**TOWNSHIP OF SOUTH WHITEHALL  
LEHIGH COUNTY, PENNSYLVANIA**

**PLANNING COMMISSION**

**DECEMBER 21, 2023**

Ruhe Subdivision Location Map Minor Subdivision #2013-201

**EXISTING FEATURES (EXPANDED VIEW, 60 SCALE)**  
**RUHE MINOR SUBDIVISION PRELIMINARY/FINAL PLAN**  
 2442 HUCKLEBERRY ROAD  
 SOUTH WHITEHALL TOWNSHIP  
 LEHIGH COUNTY, PENNSYLVANIA

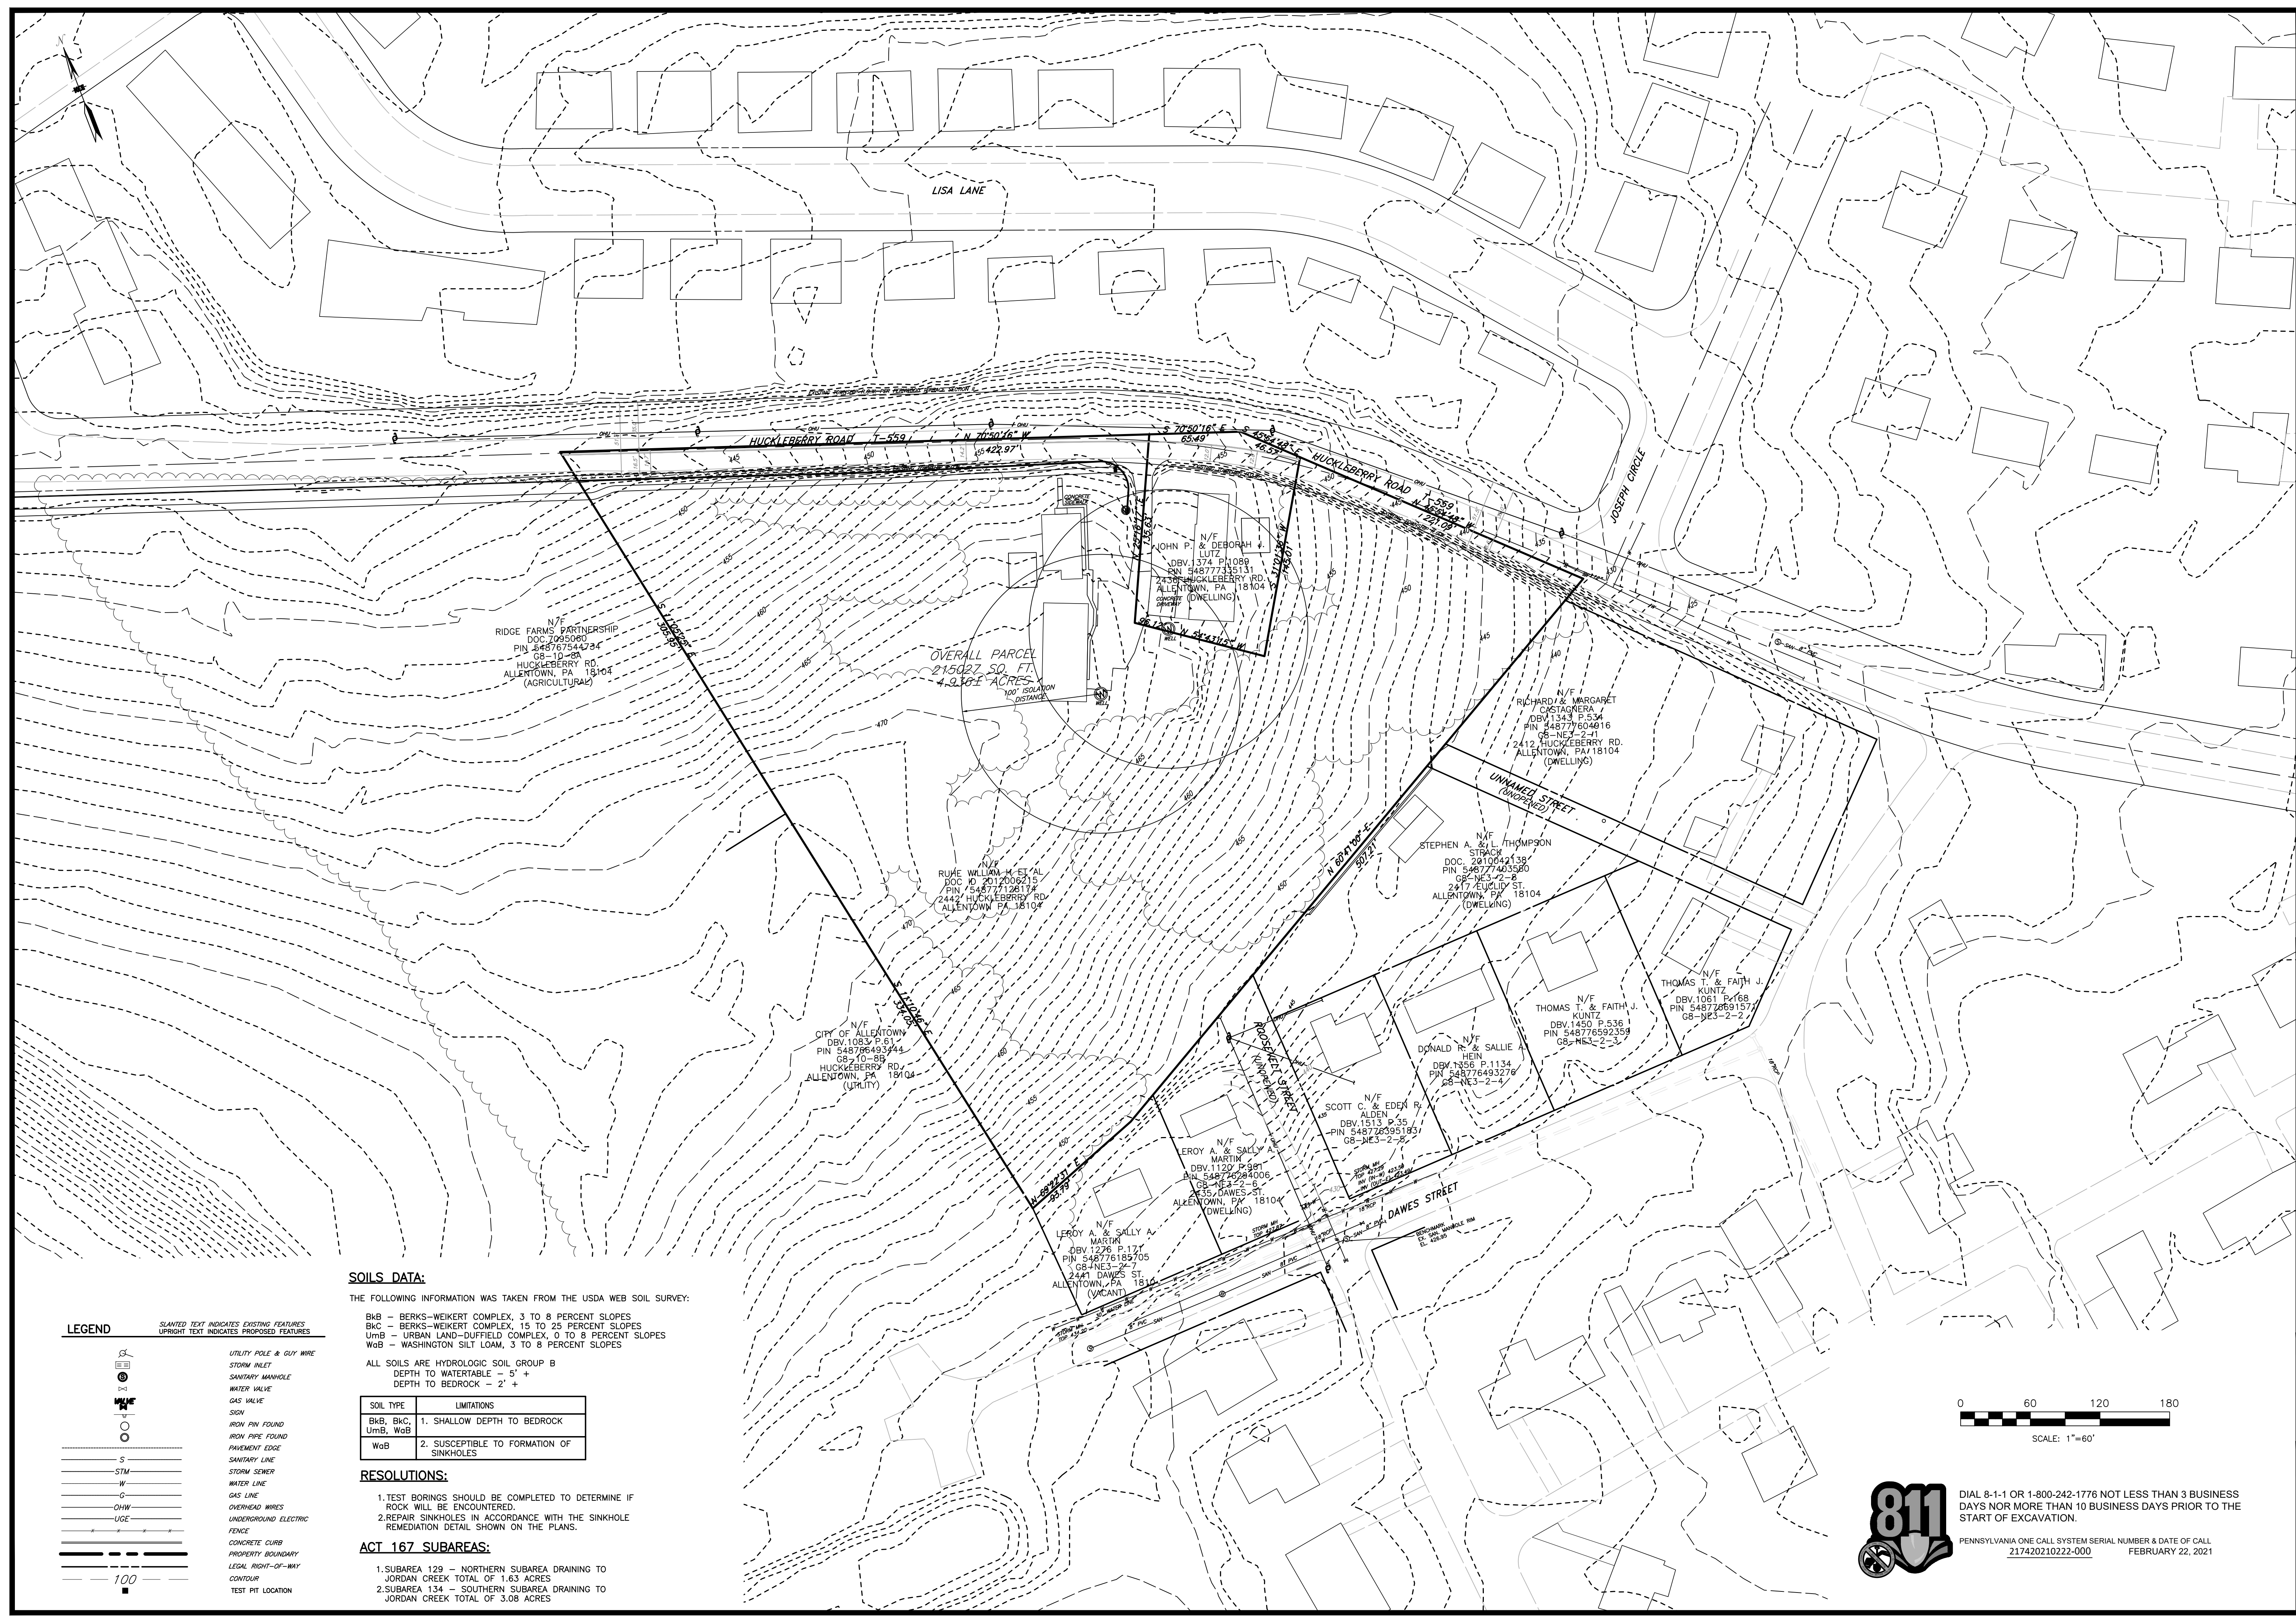
6. We note the following survey related comments:
  - a. Check the scale of the Existing Features (Expanded View, 60 Scale) Plan (Sheet 3). The plan does not appear to be drawn to scale;

**GRADING & DRAINAGE PLAN**  
**RUHE MINOR SUBDIVISION**  
**PRELIMINARY/FINAL PLAN**  
2442 HUCKLEBERRY ROAD  
SOUTH WHITEHALL TOWNSHIP  
LEHIGH COUNTY, PENNSYLVANIA

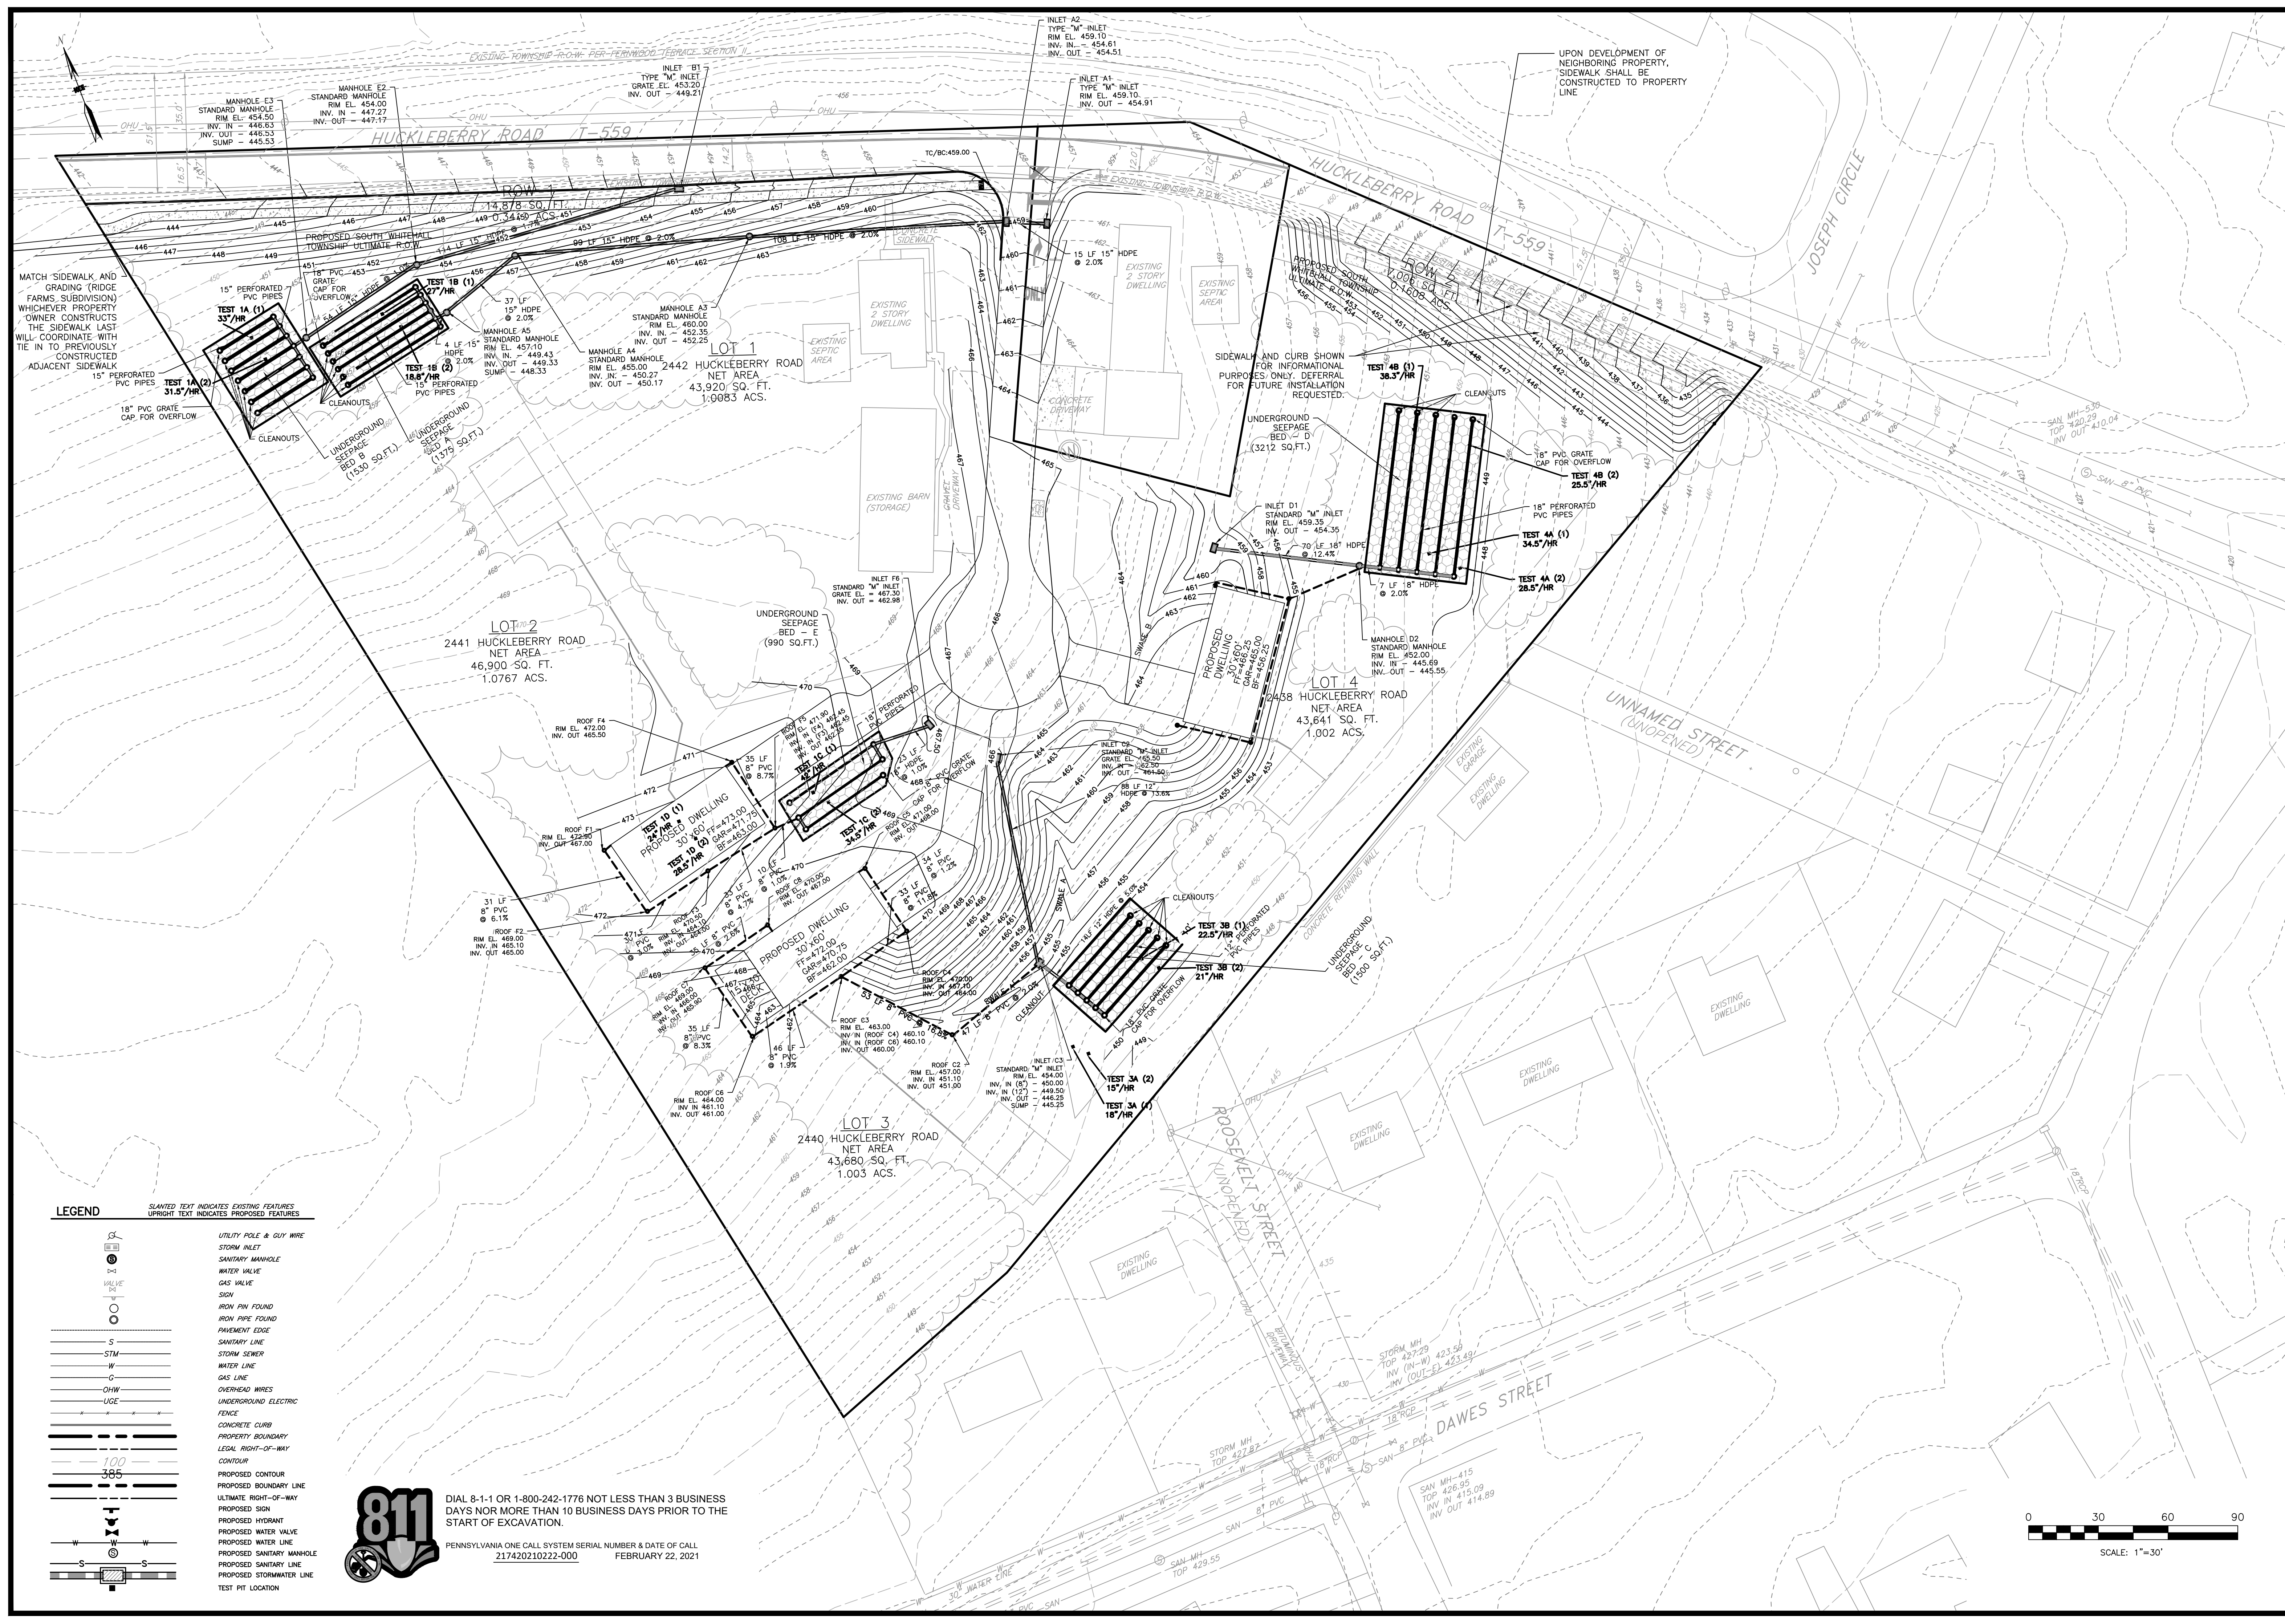
4. Grading is shown on the adjacent property to the west. In addition to the “Match Sidewalk and Grading” Note (Sheet 9) obtain and show necessary construction easements. We note that the design will lower the edge of the road approximately 2.5 feet and should be designed in a manner that will not rely on construction of the adjoining development;
